Interactive comment on “A cross-scale study for compound flooding processes during Hurricane Florence” by Fei Ye et al.

Received and published: 15 March 2021

Fig. 13: Importance of resolving small-scale features on the order of a few meters in the watershed, illustrated by a comparison between a preliminary setup (a, b) and the

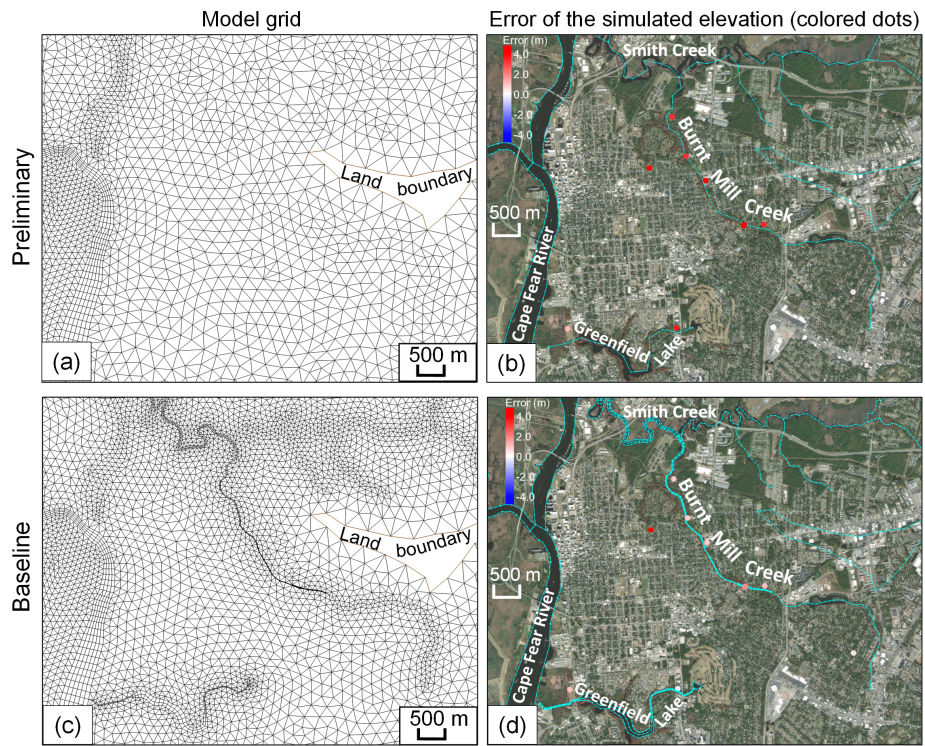
We found a minor problem with Fig. 13d and fixed it in the new Fig. 13 below. Specifically, a different run other than the baseline model was used to plot Fig. 13d in the original manuscript, which has been corrected. This does not change the conclusion that resolving small-scale flow routing features greatly improves the prediction of HWM elevation. The “Burnt Mill Creek” was mis-labeled as “Northeast Cape Fear River” in the original manuscript, which has been corrected. Lake Greenfield and more labels were also added for better illustration.
